Energy Efficient Ethernet 1000BASE-T LPI Request During Retraining

Presented by: Mike Grimwood, Broadcom

IEEE P802.3az Task Force

New Orleans, January 2010

Figure 40-15a—PHY Control state diagram, part a

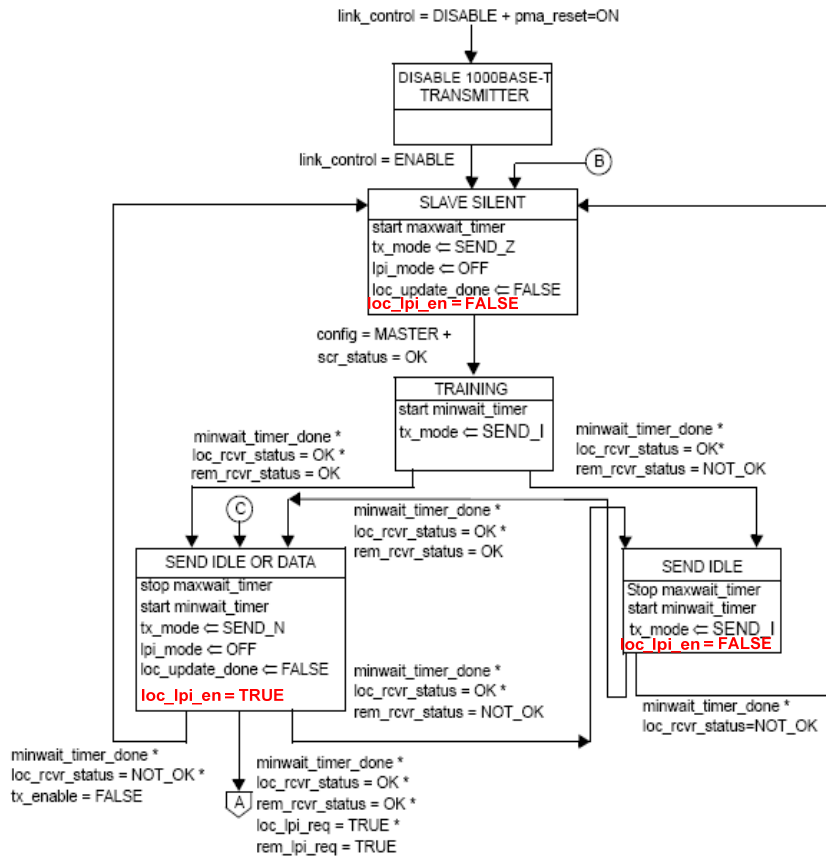
- Introduce a variable, *loc_lpi_en*, that the PHY Control State diagram sets to FALSE when it is training and to TRUE otherwise.
- Use this variable in the Local LPI Request state diagram to prevent encoding LPI requests during training.
- Add a description of *loc_lpi_en* to the PCS Transmit and state diagram variables.
- Define a PMA primitive that allows communication of *loc_lpi_en* between the PHY Control and Local LPI Request Functions.
- Illustrate the communication of *loc_lpi_en* in the Functional, PCS, and PMA block diagrams.
- Add a PICs item for *loc_lpi_en* such that it shall be FALSE in the absence of the EEE capability.

Changes to 40.2.2 and Figure 40-4 1000BASE-T Service Interfaces

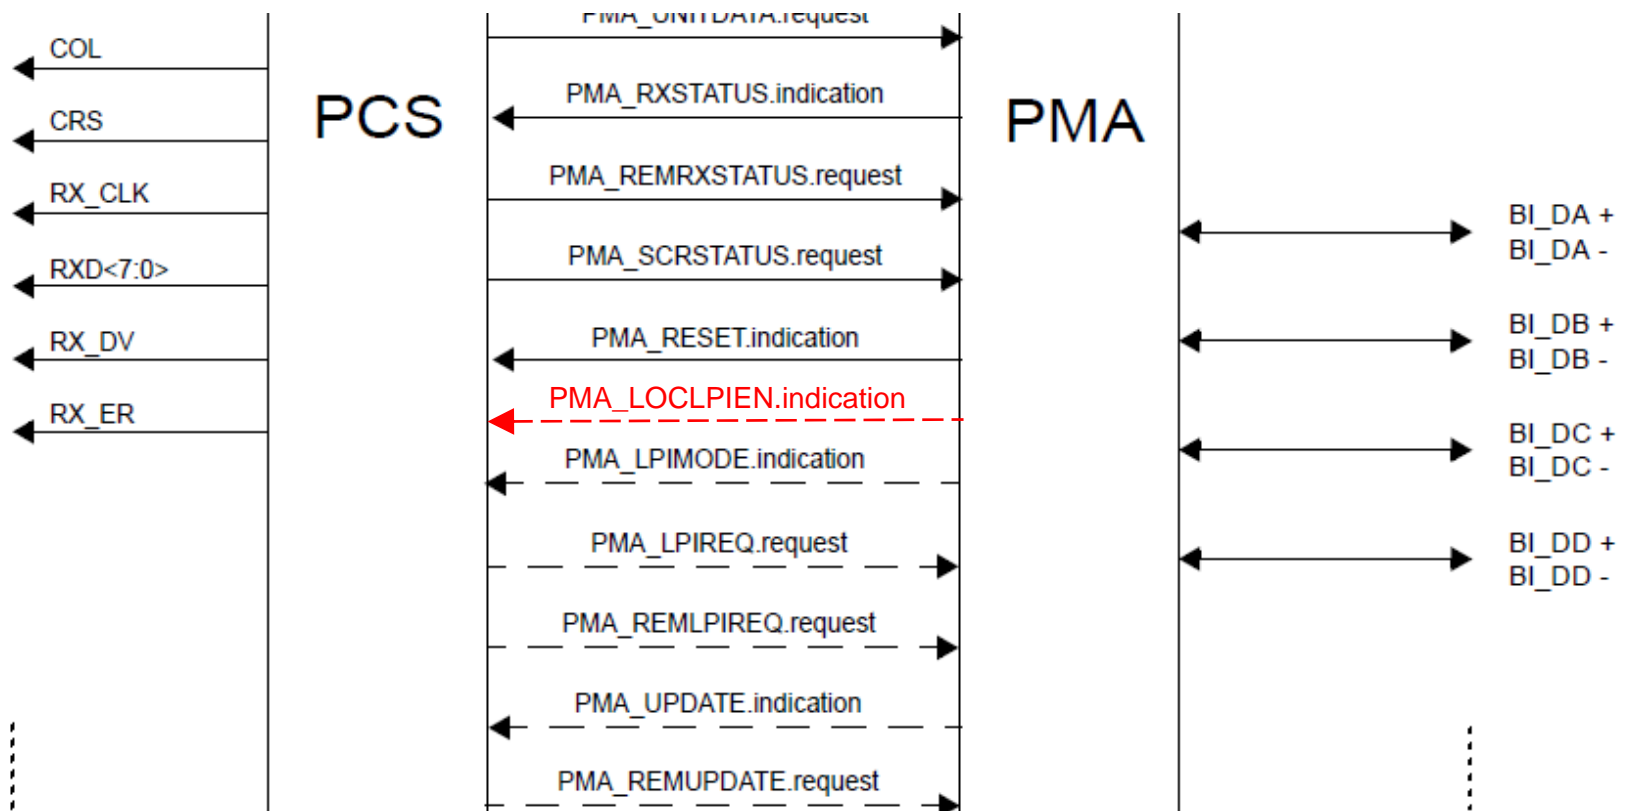
- Add to the list of PMA Service Interfaces in 40.2.2 (page 91 line 49):
 - PMA_LOCLPIEN.indication(loc_lpi_en)
